2673 – 52 Avenue Road Planning Note

Date 11/06/2024
Rev P2
Job no. 2673
Prepared by NT
Approved by KW

This report has been compiled by Heyne Tillett Steel, in conjunction with the design team, to discharge of planning condition 9 regarding the drainage strategy to the proposed development at 52 Avenue Road (planning ref. 2022/1863/P).

Drawing Title
Proposed Ground Floor
Drainage Sheet 1

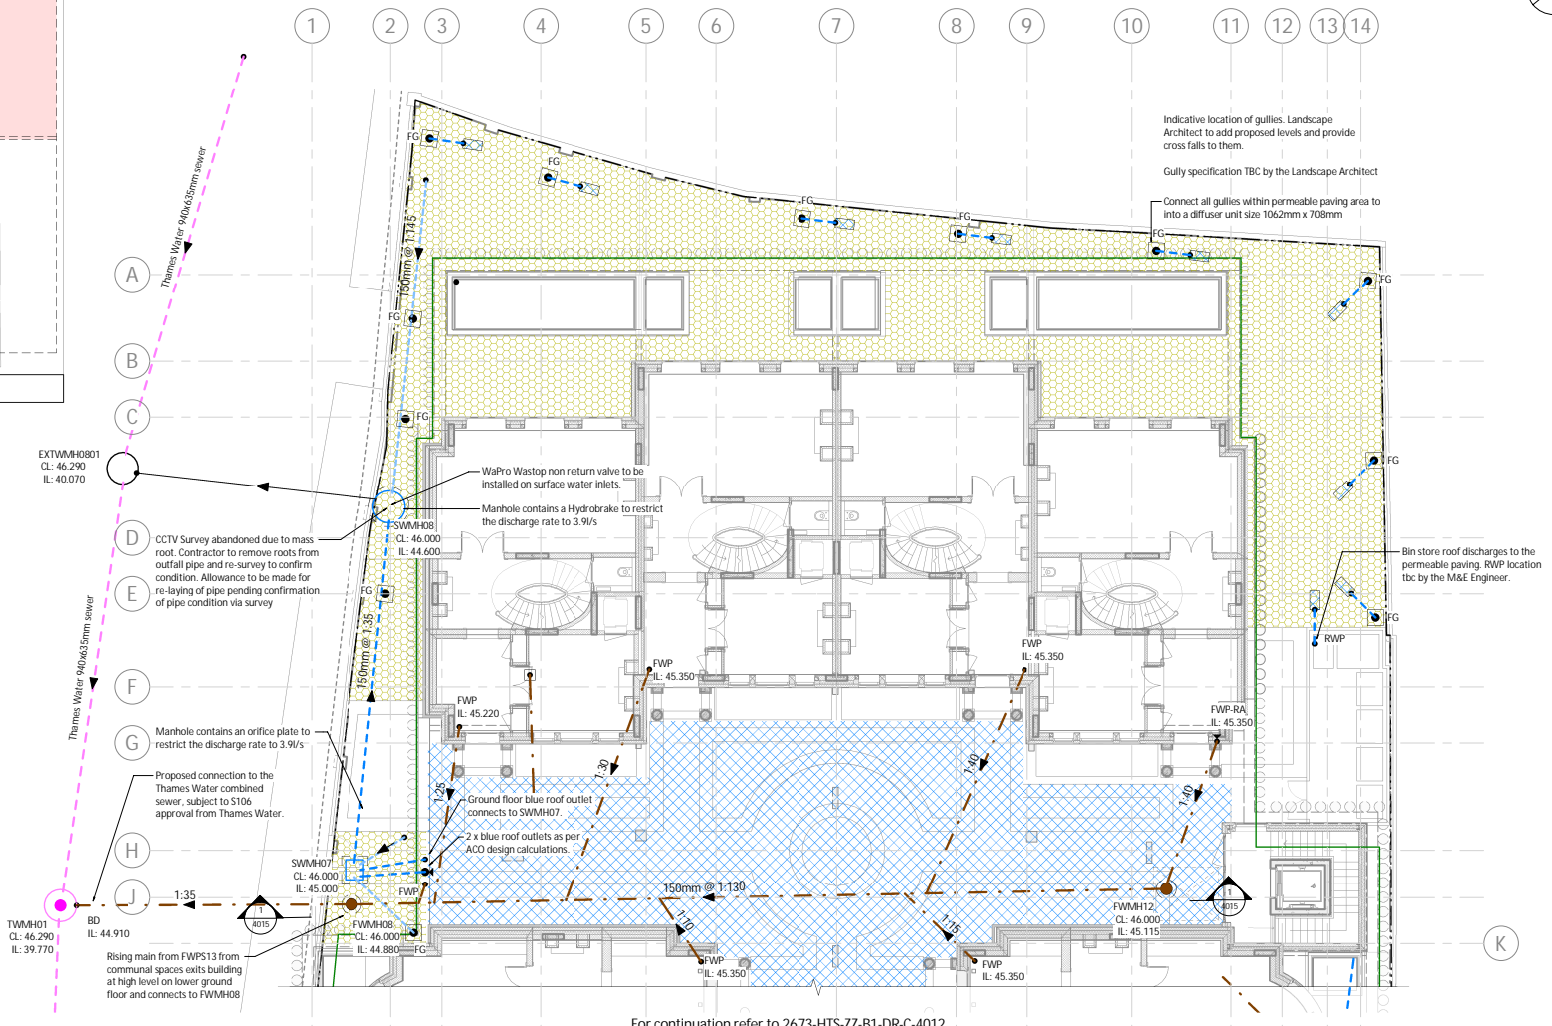
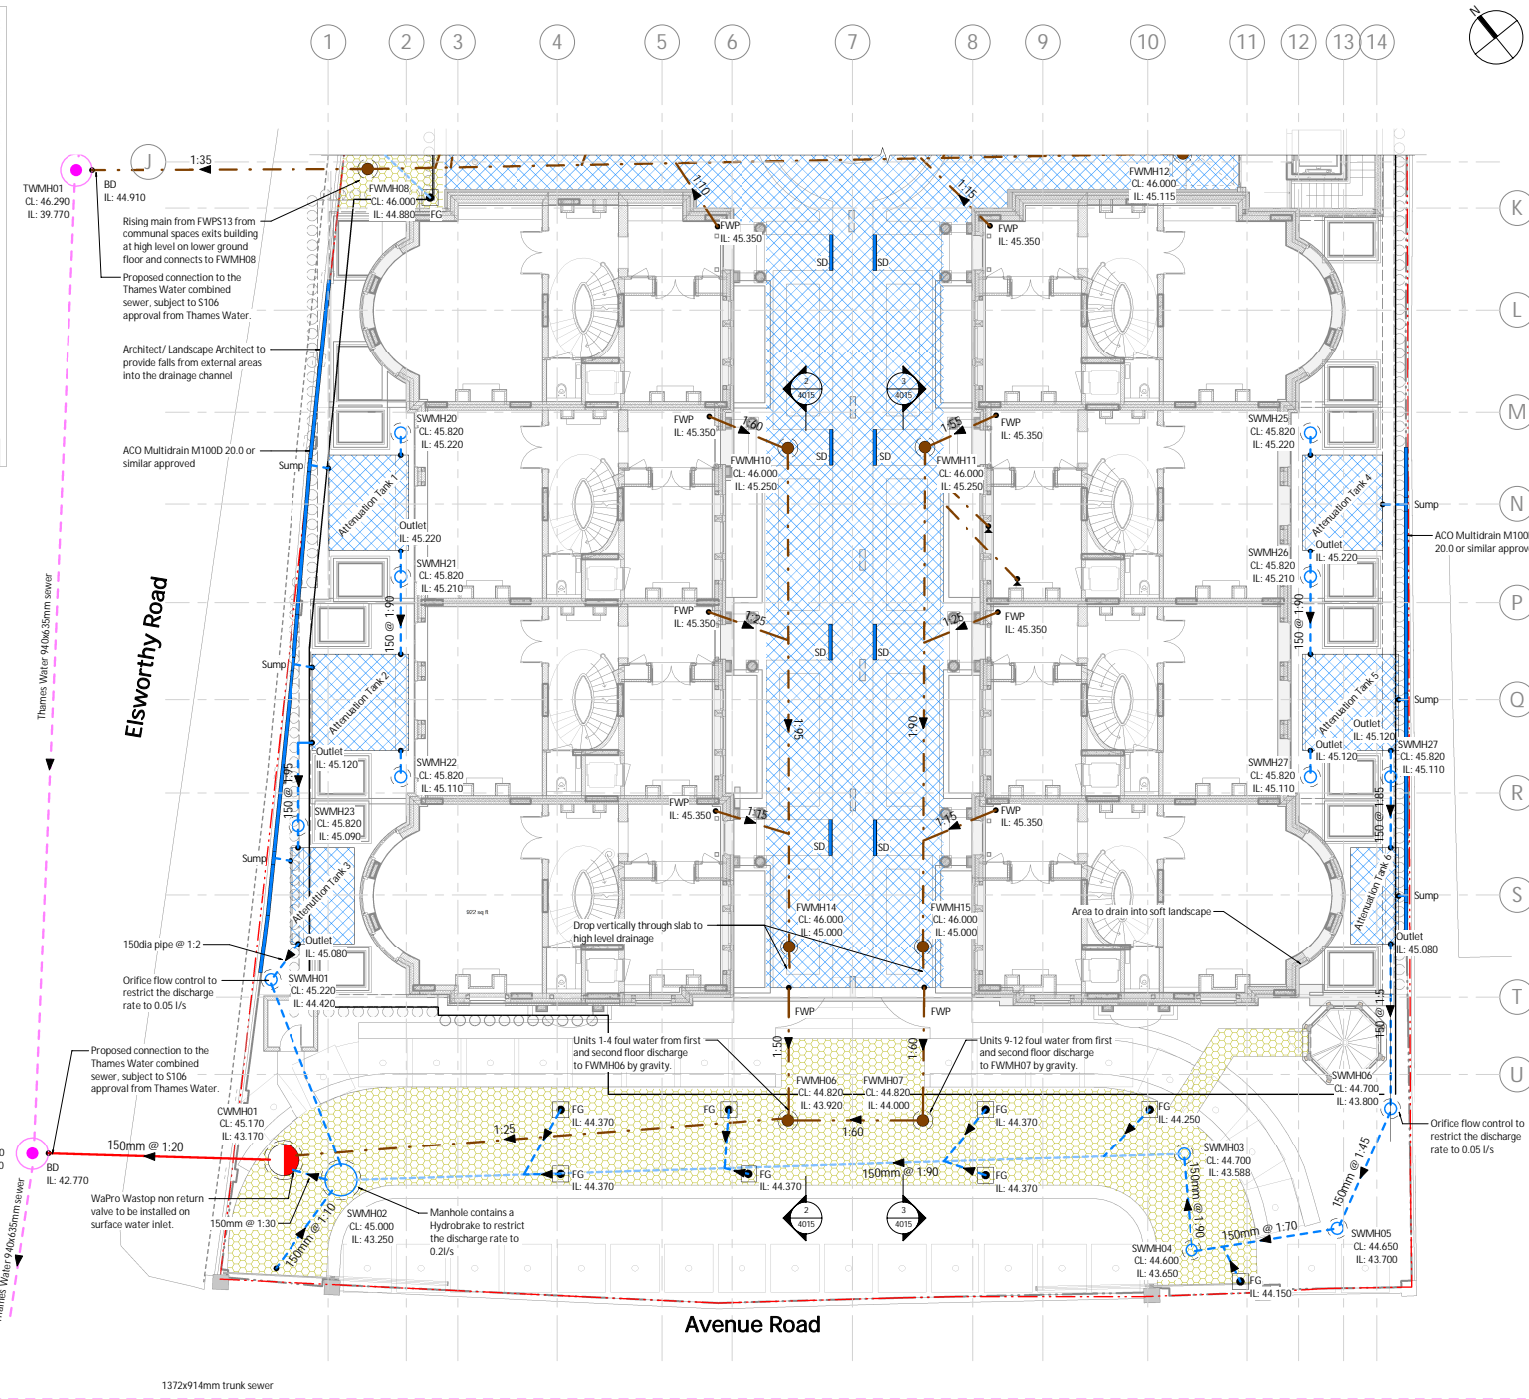
Permeable paving build up in the road located in the south of the site has been removed and replaced with a below ground attenuation tank system.

The proposed road levels slope from west to east. The proposed outfall for the road drainage is located in the west side of the site. When we modelled the permeable paving to the proposed levels in the road on Infodrainage software, the permeable paving would not work due to not being able to utilise the full depth of storage available. When working through the modelling of the system we were having to add a tank in to provide the storage volume required to meet the discharge rates (flow rate from the site 4.1l/s). Through this we determined that the most optimal design was to remove the permeable paving and just provide the storage within a tank. This is what is shown on the drawing and updated Infodrainage modelling outputs included on Appendix B.

The proposed attenuation tanks will have a total attenuation volume of 36m³ and will replace 27m³ of the permeable paving attenuation storage that was approved as part of the planning application. The updated SuDS Proforma is included on Appendix E. The proposed discharge rate from this area is 0.6l/s and the flow rate from the site will remain 4.1l/s as per the submitted scheme.

Drawing Title
Proposed Phase 1 Drainage
Layout - Access Road

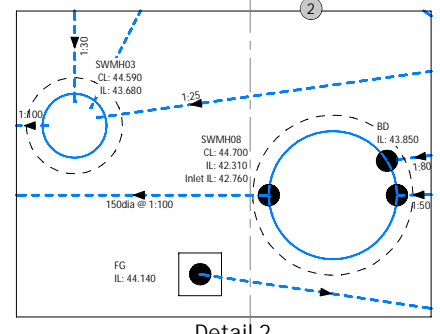
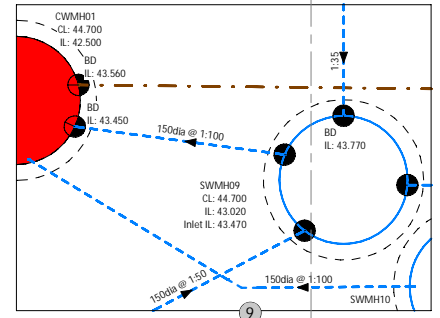
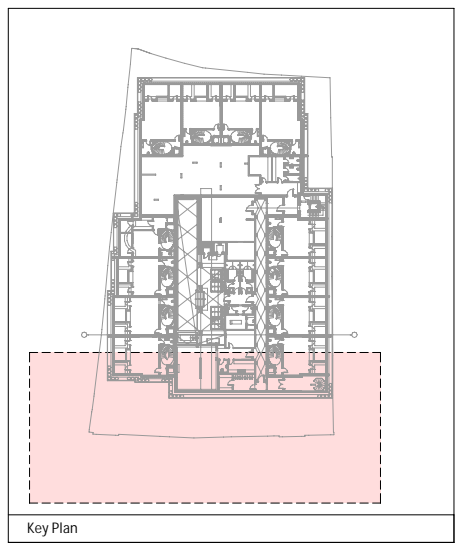
- Drainage design is assumed to be planning compliant as the same discharge rate is achieved. However, planning consultant to confirm the omission of permeable paving and introduction of a tank prior to construction.

- Attenuation tank arrangement subject to tank specialist confirmation

Drawing Title
Proposed Basement Drainage Sheet 1

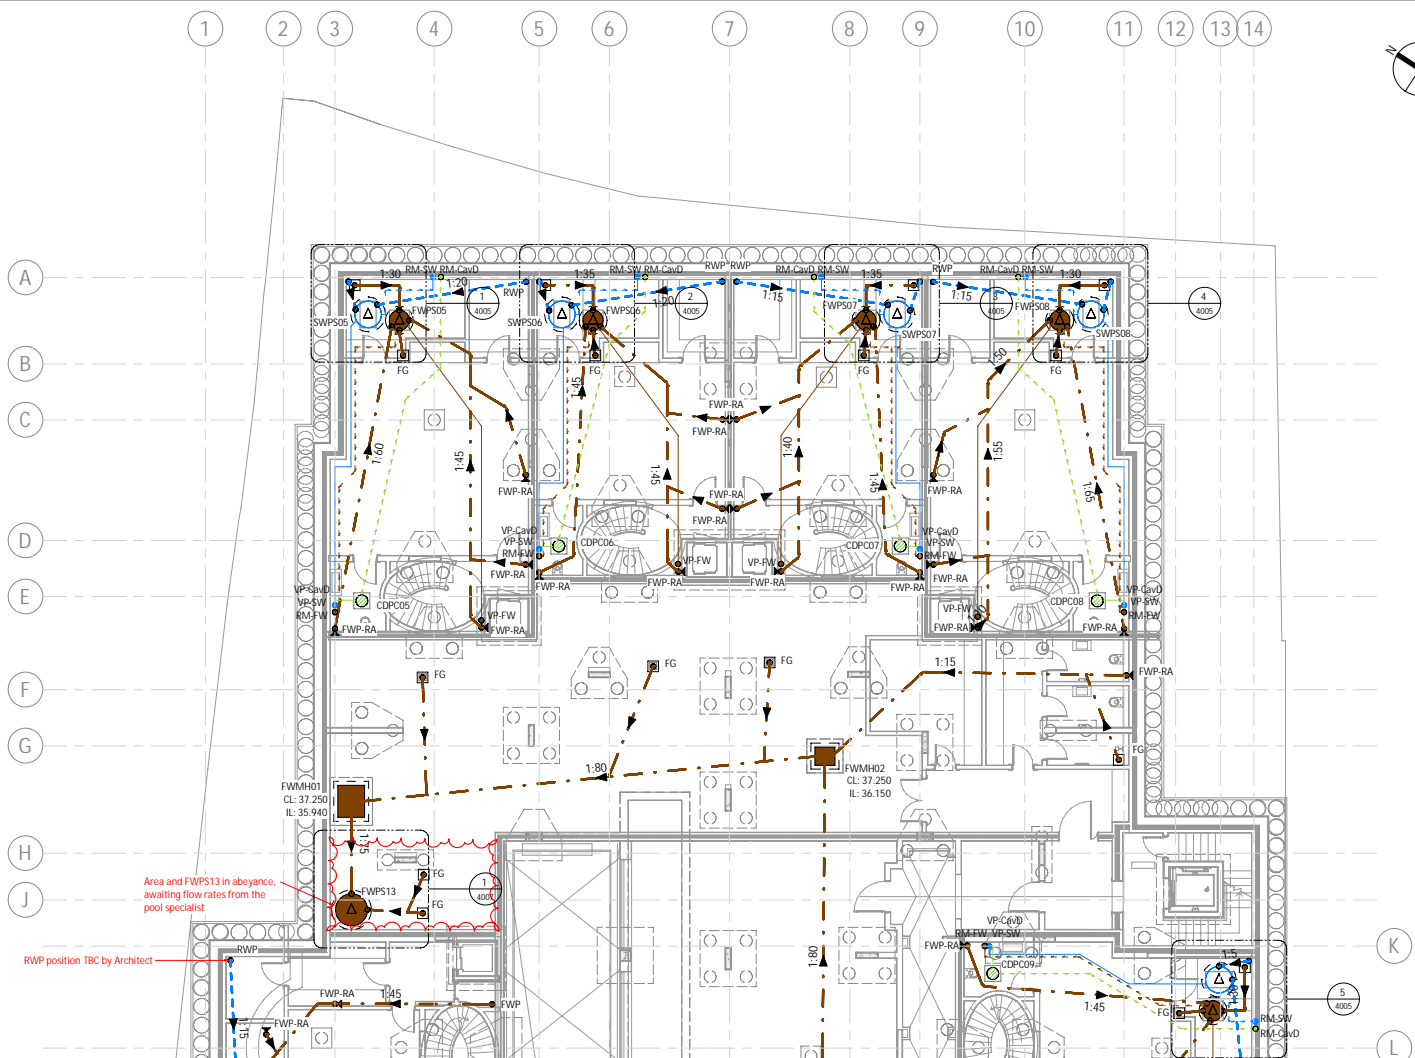
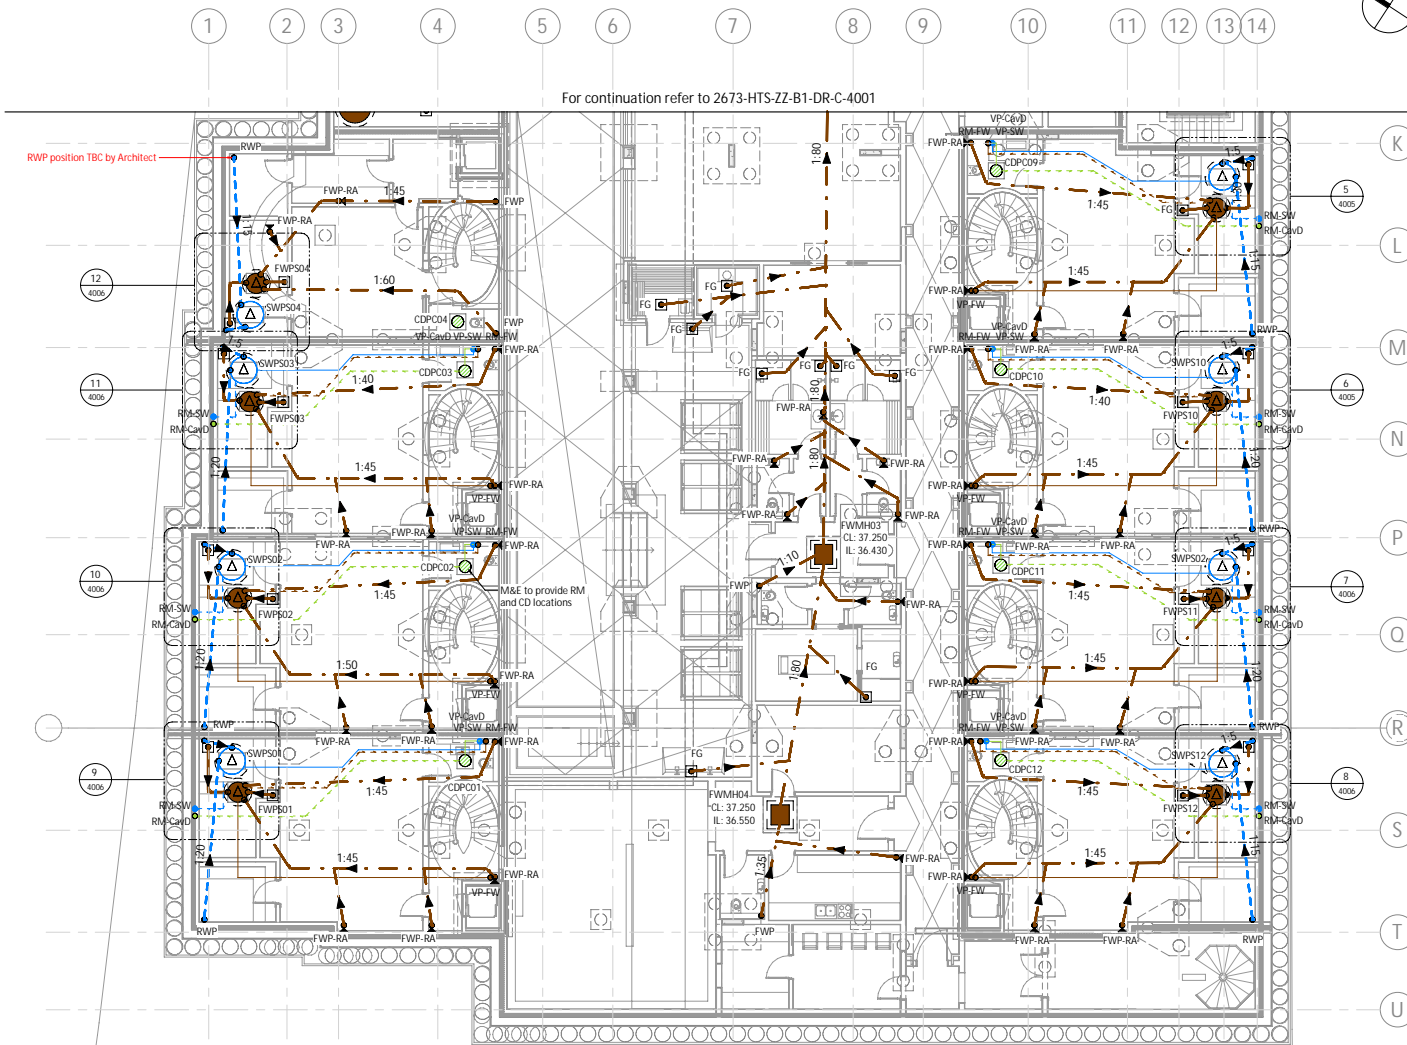
To address point a), as can be seen in Appendix C, the proposed basement level for the development is protected against sewer flooding through the use of a pumped system. As can be seen on the Proposed Basement Drainage drawings individual foul water pumps are provided for each unit. The pumps utilise a dual pump system to offset the risk of mechanical failure and they have 24-hour emergency storage provided in order to mitigate the risk of power failure.
